MINERALS PROGRAM INSPECTION REPORT**PHONE: (303) 866-3567**

MINE NAME: West Farm Pit	MINE/PROSPECTING ID#: M-2008-078	MINERAL: Gravel and sand	COUNTY: Prowers
INSPECTION TYPE: Monitoring	INSPECTOR(S): Amy Eschberger	INSP. DATE: June 14, 2018	INSP. TIME: 13:45
OPERATOR: Prowers Aggregate Operators, LLC	OPERATOR REPRESENTATIVE: Ron Peterson	TYPE OF OPERATION: 112c - Construction Regular Operation

REASON FOR INSPECTION: Citizen Complaint	BOND CALCULATION TYPE: None	BOND AMOUNT: \$575,000.00
DATE OF COMPLAINT: June 11, 2018	POST INSP. CONTACTS: Colorado Parks & Wildlife	JOINT INSP. AGENCY: Colorado Parks & Wildlife - Jim Ramsay
WEATHER: Clear	INSPECTOR'S SIGNATURE: 	SIGNATURE DATE: July 12, 2018

M2008-078 / Prowers Aggregate Operators, LLC / (Image data from 6/12/2017)

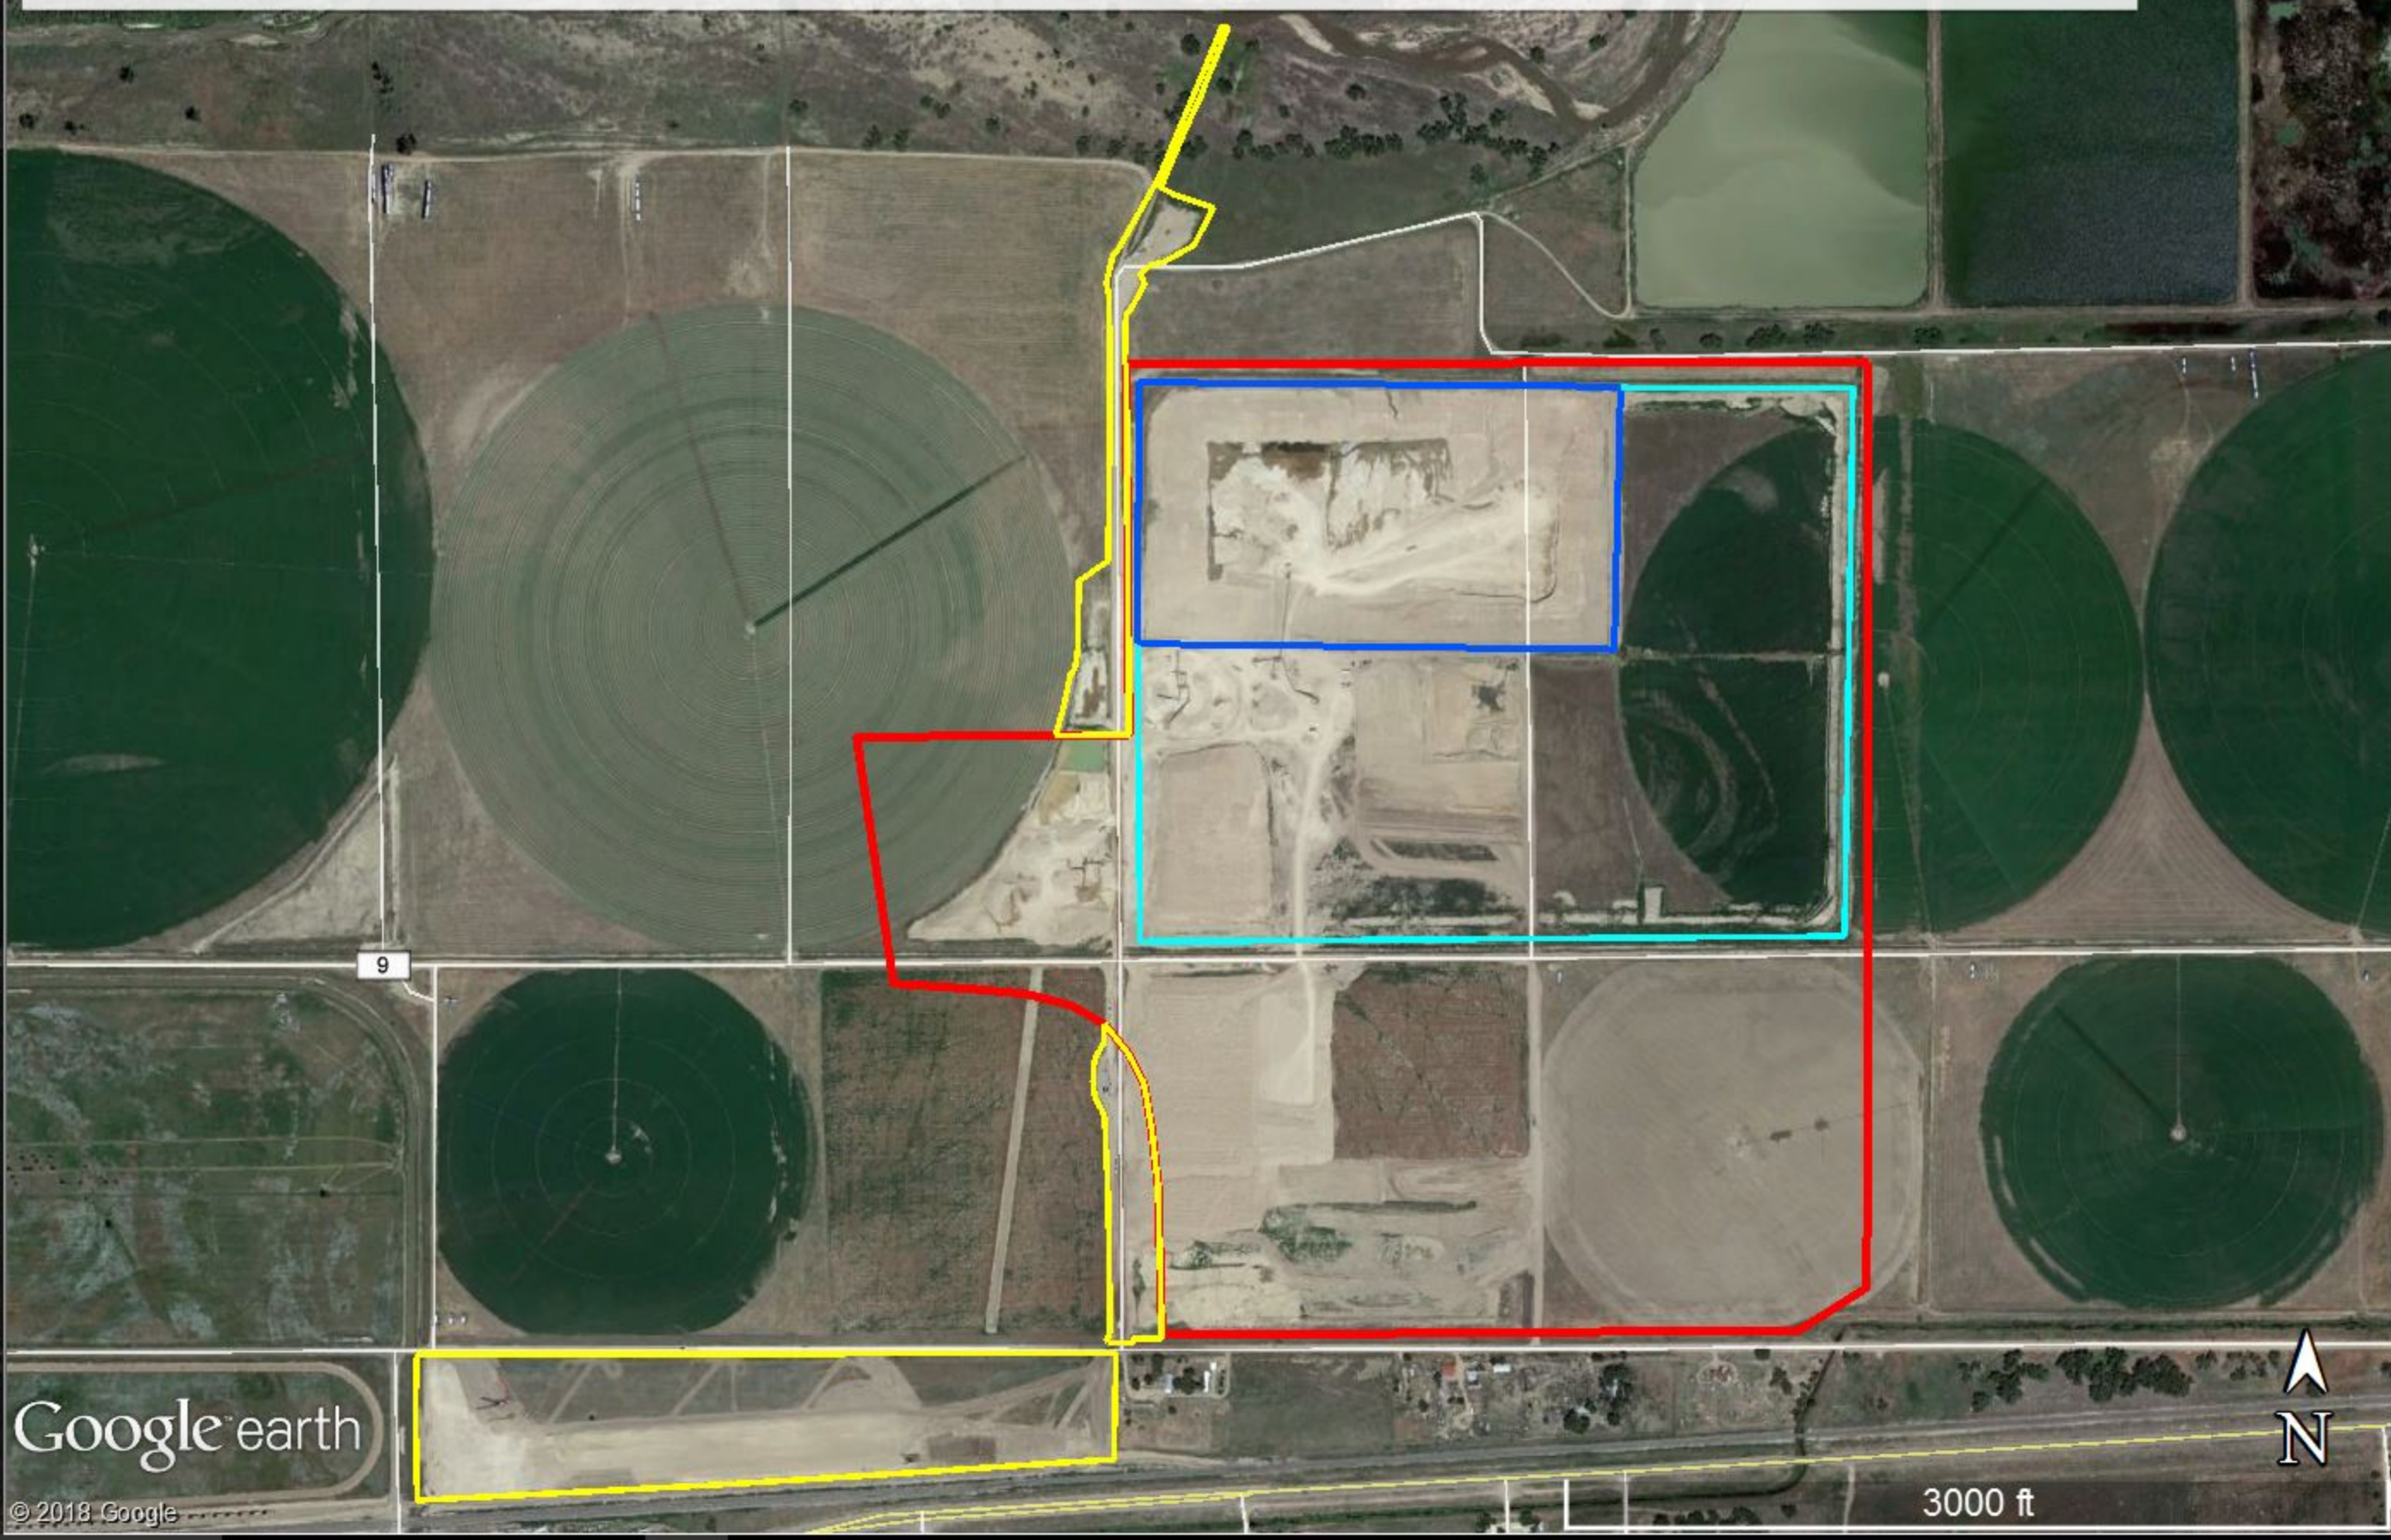
The Division estimates the operation has disturbed a total of 177 acres (see enclosed Google Earth images of site). Disturbance in the North Mining Area includes two slurry wall installations, two mined pits, a material crushing/screening plant, a material wash plant and associated facilities (i.e., settling ponds, ditches), material stockpiling areas, equipment/truck storage areas, and haul roads. Disturbance in the South Mining Area includes material stockpiling areas, topsoil/overburden storage areas, a scale house, and haul roads. The Division estimates 37.52 acres of the disturbance occurred outside of the approved permit boundary. The off-site disturbance includes at least one of the settling ponds, the ditch in which the wash plant wastewater was released to the river, an equipment/truck storage area located north of the mine (**Photo 12**), the scale house area (**Photo 13**), the western edge of the material and topsoil/overburden stockpiles in the South Mining Area (**Photo 14**; also shown in Photo 13), haul roads (agricultural roads widened for mine traffic), and a 26.8 acre area located just southwest of the mine site where sand is being stockpiled adjacent to the railroad (**Photos 15 and 16**).

The Division considers the amount of off-site damage to be substantial pursuant to C.R.S. 34-32.5-123(2). All affected lands must be incorporated into the permit area through submittal of a permit Amendment. A Possible Violation is cited in this report for failure to first obtain from the MLRB or Office a reclamation permit prior to engaging in a new operation as required by C.R.S. 34-32.5-109(1). This Possible Violation will require a hearing before the Mined Land Reclamation Board. Details for the Board hearing will be mailed separately via Certified Mail.
